# Access Compliance Report

## Public Rights-of-Way

### (Curb Ramps)

Intersection ID: 30544	Main Street: STONECROFT_PARK_DR	Cross Street: SUMMERHILL_RIDGE_DR	Location: SW
ADA ID: DAB80890353E	Ramp Type: PerpDiag	Initial Pass/Fail: Fail	Overall Compliance: No
Severity Score: 33.75			
Codes/Mitigation Info/Possible Solution		Field Measurements/Component Compliance

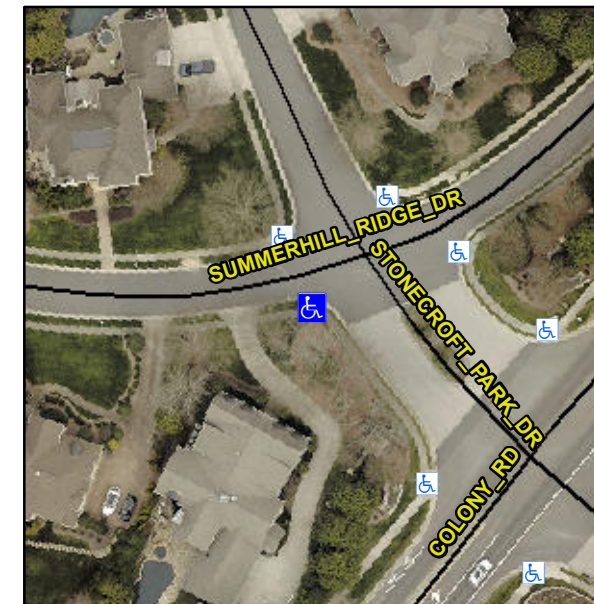
**Not Found, R304.5.1, R304.5.3**

Compliance	Description	Data	Compliance	Description	Data
N/A	Ramp Length (in)	30.0	Yes	Ramp Slope (%)	7.1
No	Ramp Width (in)	43.0	No	Ramp XSlope (%)	7.4
N/A	Flare Type LT	N/A	N/A	Flare Type RT	N/A
N/A	Flare Slope LT (%)	N/A	N/A	Flare Slope RT (%)	N/A
N/A	Flare Traversable LT?	N/A	N/A	Flare Traversable RT?	N/A
N/A	Landing Length (in)	N/A	N/A	DWS Provided?	N/A
N/A	Landing Width (in)	N/A	N/A	DWS Contrast?	N/A
N/A	Landing Slope (%)	N/A	N/A	DWS Length (in)	N/A
N/A	Landing X Slope (%)	N/A	N/A	DWS Full Width?	N/A
N/A	Landing Curb? (Y/N)	N/A	N/A	DWS Offset (in)	N/A
N/A	Shared Landing?	N/A			
N/A	Gutter Ponding?	N/A	N/A	Gutter Slope (%)	N/A
N/A	Gutter Lip Ht (in)	N/A	N/A	Gutter X Slope (%)	N/A
N/A	Painted X Walk1?	No	N/A	Painted X Walk2?	No
	X Walk 1 Direction	To NE		X Walk 2 Direction	To NW
N/A	X Walk 1 Width (in)	N/A	N/A	X Walk 2 Width (in)	N/A
	X Walk 1 Slope (%)	4.5		X Walk 2 Slope (%)	2.4
	X Walk 1 X Slope (%)	4.1		X Walk 2 X Slope (%)	4.2

**Remove & Replace Curb Ramp With Two New Directional Ramps or Equivalent.**
